NEW SUMMARY OF SUBMISSIONS
Serpentine Townsite Local Structure Plan
SJ993-02

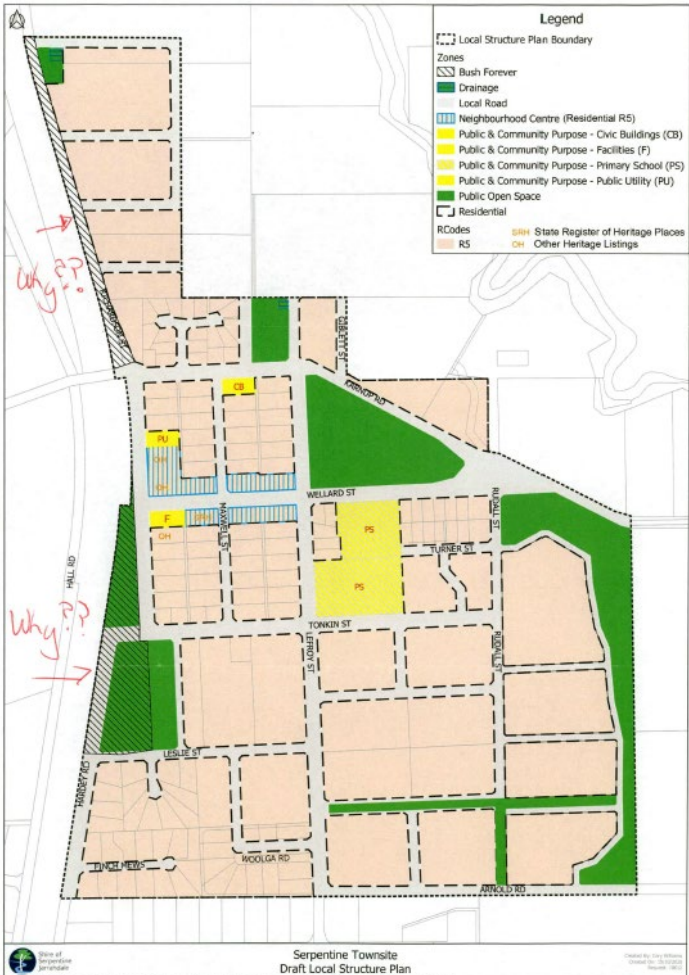
Submitter	No	Submitter Comments	Officer Comment	Officer Recommendation
		 <p data-bbox="566 1114 1411 1136">Figure 1: "Richardson St Precinct" excerpt from Advertised Serpentine Townsite LSP</p> <p data-bbox="506 1189 1473 1418">This submission requests that the northernmost road (within Lot 10, adjacent to the north of the subject site), be moved wholly into our Clients landholding. It also requests a slight adjustment to the road adjacent to the southern boundary of Lot 12 to ensure appropriate lot sizes can still be achieved. The rationale for this amendment is that there is very little incentive for the landowner of Lot 10 to develop their site, which would have the effect of significantly limiting development on our Clients lot,</p>	<p data-bbox="1503 432 1839 866">Lot 10. Officers agree that there would be little practical way for the landowner of Lot 10 to develop, given small portion of land identified as residential on this lot. Furthermore, Lot 12 Richardson Street will require the road access identified on Lot 10 to enable development to occur.</p> <p data-bbox="1503 906 1839 1414">Officers support relocating the east-west road, currently identified on Lot 10 at the northern structure plan boundary, to the northern boundary of Lot 12. The road would be wholly contained within Lot 12, providing the necessary access to allow Lot 12 to develop independently of Lot 10. This would result in a larger portion of Lot 10 being identified as</p>

Submitter	No	Submitter Comments	Officer Comment	Officer Recommendation
		<p>because of the following reasons:</p> <ol style="list-style-type: none"> 1. The proposed road, which occurs on the northern perimeter of the LSP area, will traverse right through the dwelling on Lot 10, as evidenced by Figure 2 below, which depicts the location of the dwelling in relation to the Urban Development zone. 2. Given the road and Public Open Space areas on Lot 10 consume a large portion of its developable area, Lot 10 will only be able to accommodate part lots, thereby reducing development incentive even further. <p>Because of these constraints, we propose that the road and adjacent Public Open Space (and drainage basin) be moved entirely into Lot 12. This scenario has been illustrated on a Concept Plan that is attached at Appendix A. The effect of this adjustment will achieve the following outcomes:</p> <ol style="list-style-type: none"> 1. Lot 12 will be able to be entirely developed in its own right, which ensures that development in the LSP Area can occur to the proposed potential. 2. The POS and associated drainage area can easily be ceded and developed as part of the development of Lot 12. In the current proposal this would be contingent on the development of Lot 10, which is unlikely as explained above; and 3. More incentive is provided to the landowner of Lot 10 given the existing dwelling will no longer be impacted by the proposed road, and because entire lots (as opposed to partial) can be developed on that site. 	<p>Residential, which would allow lots to also be created from Lot 10.</p> <p>Given the recommended relocation of the northernmost east-west road further south, officers support moving the other road at the southern boundary of Lot 12 slightly to the south, to ensure appropriate lot sizes can be achieved.</p> <p>An area of POS is also located over both Lot 10 and Lot 12 Richardson Street. Officers agree that the development of this POS may be challenging given the limited amount of residential land identified on Lot 10, resulting in a lack of incentive for Lot 10 to develop. Officers support the relocation of the POS and drainage to</p>

Submitter	No	Submitter Comments	Officer Comment	Officer Recommendation
		 <p style="text-align: center;">Figure 2: Position of Dwelling on Lot 10 (No. 116) in comparison with Urban Development Area</p> <p>Whilst we understand that the likely design motive of the draft LSP was to ensure a hard edge (i.e. road edge) to this particular portion of the Structure Plan area, we reiterate that this would have significant consequence to the developability of Lots 10 and 12 as demonstrated above. For that reason, we request that the Shire consider this statement favourably.</p>	be wholly contained within Lot 12 Richardson Street. This would allow for the POS to be delivered as a part of the development of Lot 12.	
Neighbour

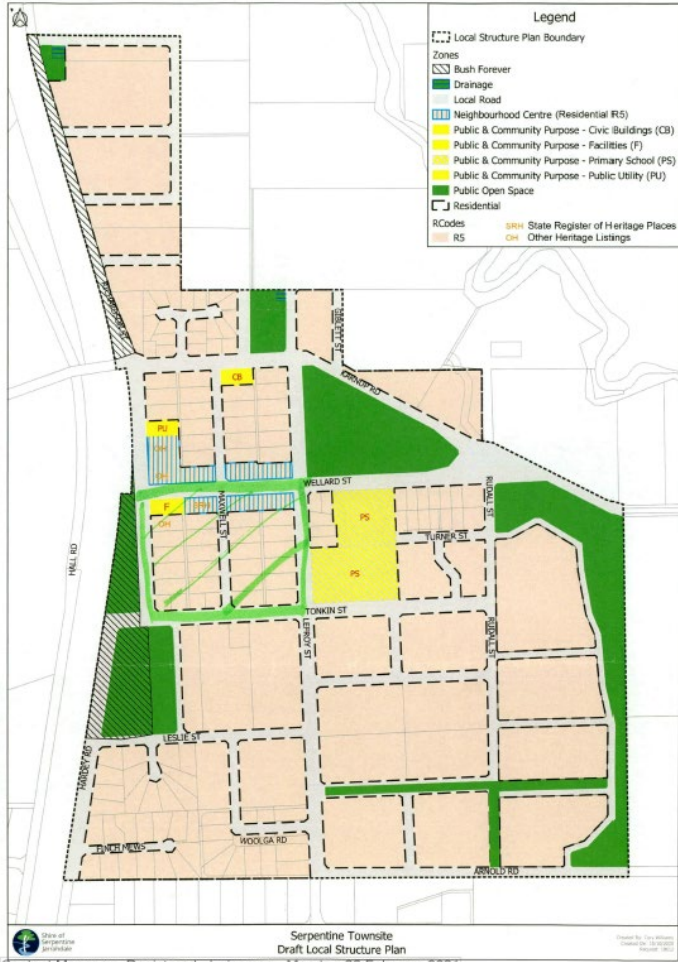
M. Lockwood IN21/4153	19.	<p>Why are you blocking off Richardson Street North when we just spent over a million dollars upgrading the bridge? How do we get to Mundijong? Why would you block off Hardey Road North to create a greater bushfire risk and a longer route to town for those living in Serpentine South West?</p>	<p>Noted.</p> <p>Richardson Street North is not proposed to be closed. The hatching over Richardson Street on the structure plan map indicates a Bush</p>

Submitter	No	Submitter Comments	Officer Comment	Officer Recommendation
		 <p style="text-align: center;">Serpentine Townsite Draft Local Structure Plan</p> <p>Content Manager - Registered - kwiseman - Friday, 12 February 2021</p>	<p>Forever designation. Bush Forever areas are identified under the Metropolitan Region Scheme to protect and manage regionally significant bushland. A Bush Forever designation can occur over a road reserve. These parts of road with the Bush Forever designation are not proposed to be closed.</p>

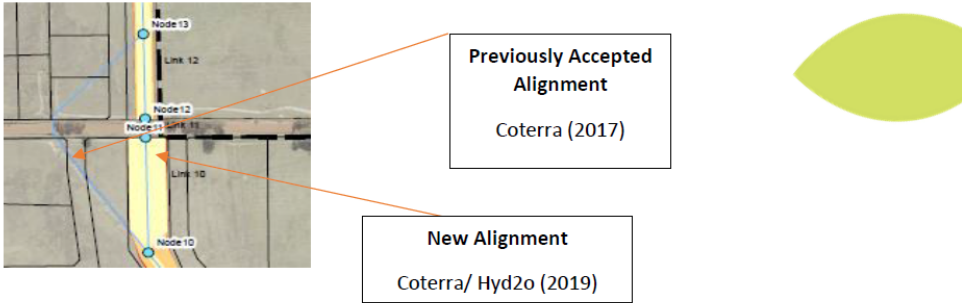
Submitter	No	Submitter Comments	Officer Comment	Officer Recommendation
			<p><i>endorsed by the Shire of Serpentine-Jarrahdale on 20 April 2020 and identifies aspirational cycle routes within the Local Structure Plan area, including on Karnup Road, Wellard and Lefroy Streets. This will provide good cycle linkages to the neighbourhood centre, school and community facilities as well as the proposed residential lots to the north of the neighbourhood centre and should be incorporated into the structure plan. An extension of the proposed cycle network to incorporate the new proposed road network to the south of the structure plan should be included to ensure a complete and connected cycle network for the</i></p>	<p><i>2020 and identifies aspirational cycle routes within the Local Structure Plan area, including on Karnup Road, Wellard and Lefroy Streets. This will provide good cycle linkages to the neighbourhood centre, school and community facilities as well as the proposed residential lots to the north of the neighbourhood centre and should be incorporated into the structure plan. An extension of the proposed cycle network to incorporate the new proposed road network to the south of the structure plan should be included to ensure a complete and connected cycle</i></p>

Submitter	No	Submitter Comments	Officer Comment	Officer Recommendation
			<i>town. Bicycle access in the LSP area is to be in accordance with the Shire's Local Area Bicycle and Shared Path Plan.'</i>	<i>network for the town. Bicycle access in the LSP area is to be in accordance with the Shire's Local Area Bicycle and Shared Path Plan.'</i>
R Schmidt E21/2351	25.	Your plan for the area around Turner St is incorrect. It shows Turner St as a straight road, with a new road joining onto it through the Uniting Church grounds. However Turner St is actually curved around a significant flora sight, which actually takes away quite a bit of land from the home owners. It is a Private Road. I'd suggest the Shire actually visit and inspect the area. They never visit the street to do any work, so doubt they know it even exists.	Noted. The structure plan map depicts the existing Turner Road reserve. The Turner Road reserve includes road pavement and the significant vegetation protected within the road reserve.
